Permit Number: 081287

has permission to Lobby & Facade Improvements

AT 245 COMMERCIAL ST CBI 038 F006001

From Designer: PDT Architects
 Date: 10/03/08
 Job Name: Renovation @ 245-251 Commercial Street
 Address of Construction: 245-251 Commercial Street, Portland, ME 04101

3 PARTIAL ELEVATION - FIFTH FLOOR DECK
1/8" = 1'-0"

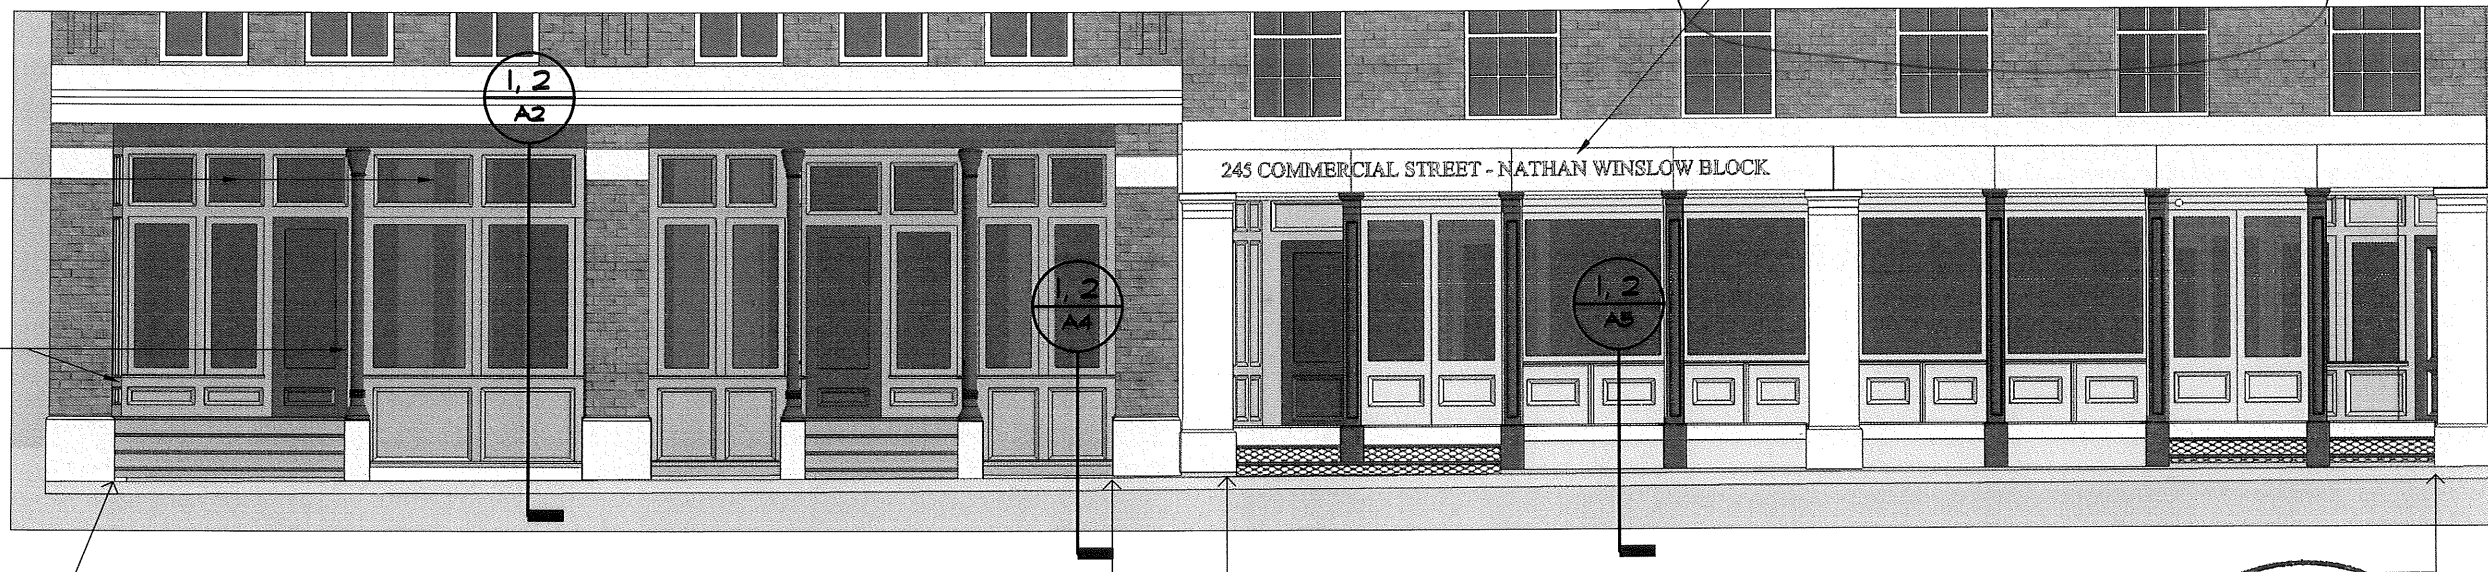
- ① Detail on deck- balluster spacing
- ② New wall required to be rated (inter)
- ③ Fire blocking of concealed spaces
- ④ Thickness of wall + location of extent of length of wall.
- ⑤ Ext wall needs to be metal studs

The handrail detail is an extension of an existing handrail which is not the correct height. There is no glass.

POWDER-COATED GUARDRAIL
EXTENSION- TOP RAIL TO BE
42" ABOVE DECK FLOOR.
MATCH COLOR & MATERIALS
OF EXIST. HANDRAIL.

LENGTH OF NEW HANDRAIL TO MATCH EXIST.

2 FOUNDATION DETAIL
3/4" = 1'-0"

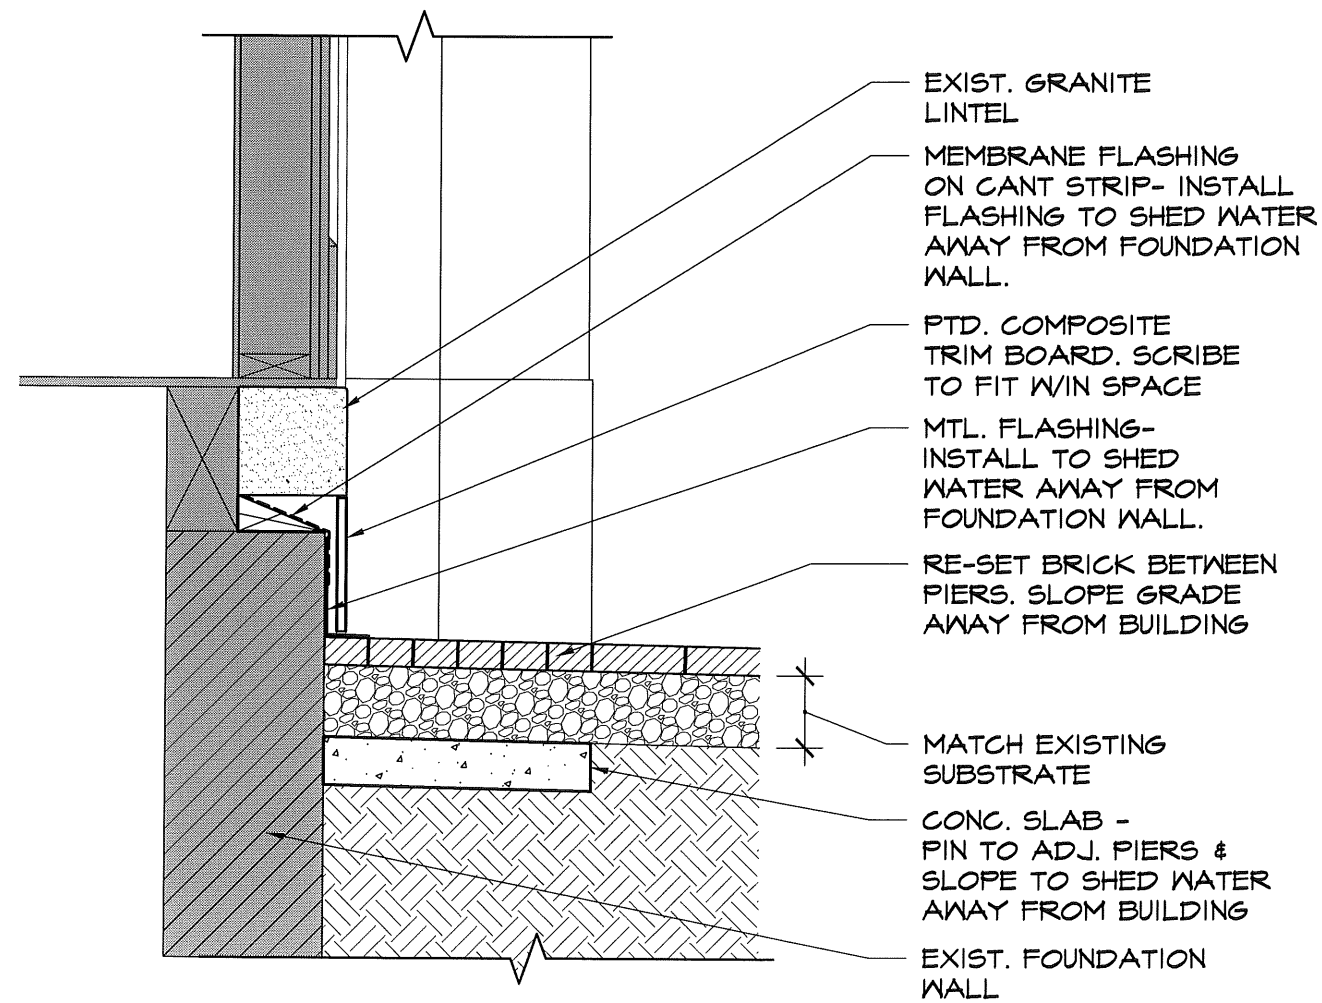
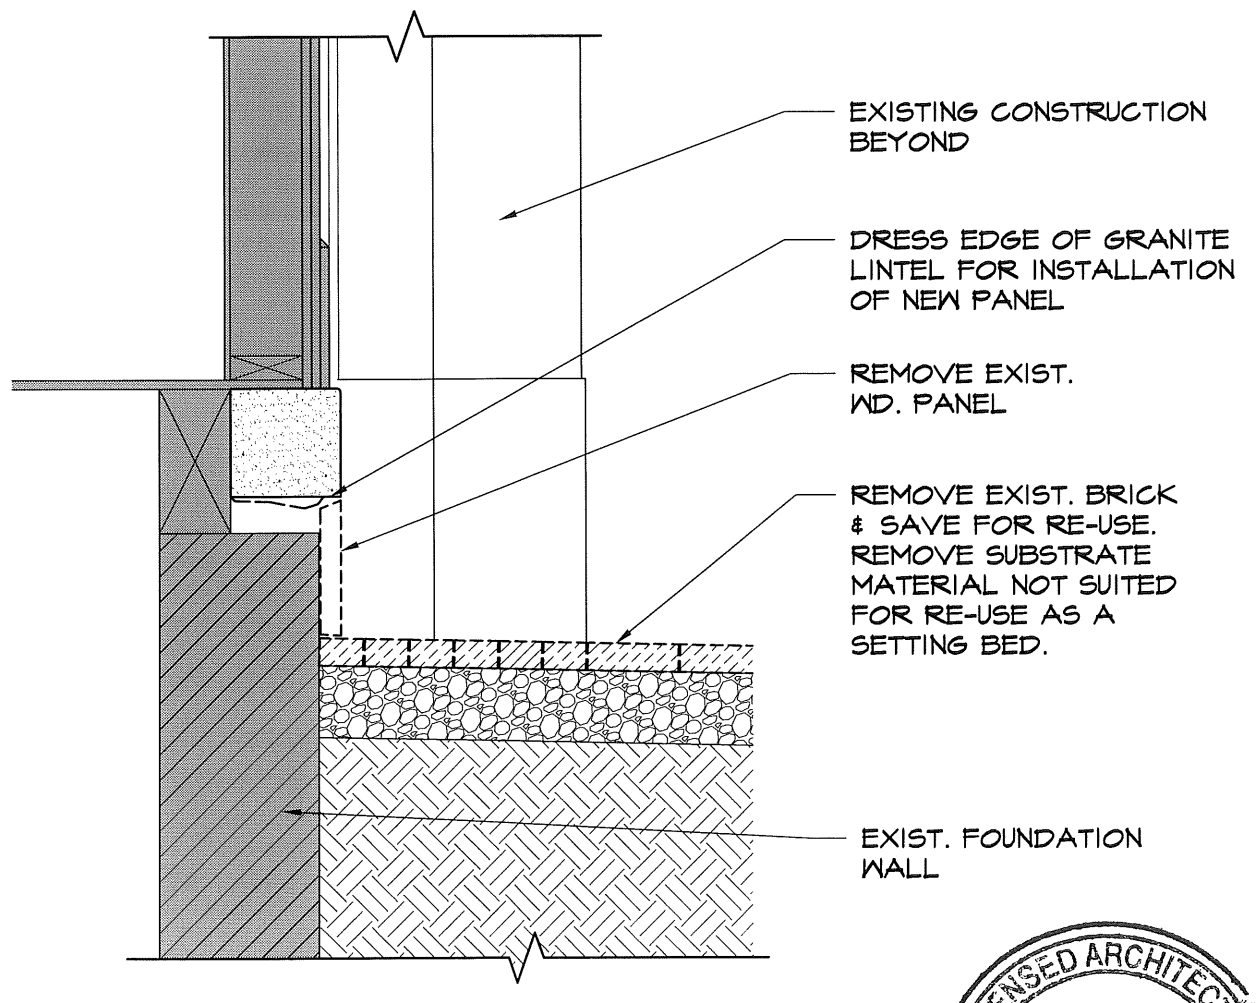
Attached are more clarifications to the drawings for 245-251 Commercial Street. We were unable to determine the total thickness of the foundation wall and footing. The concrete infill is intended to fill in the void between the existing concrete foundation walls.
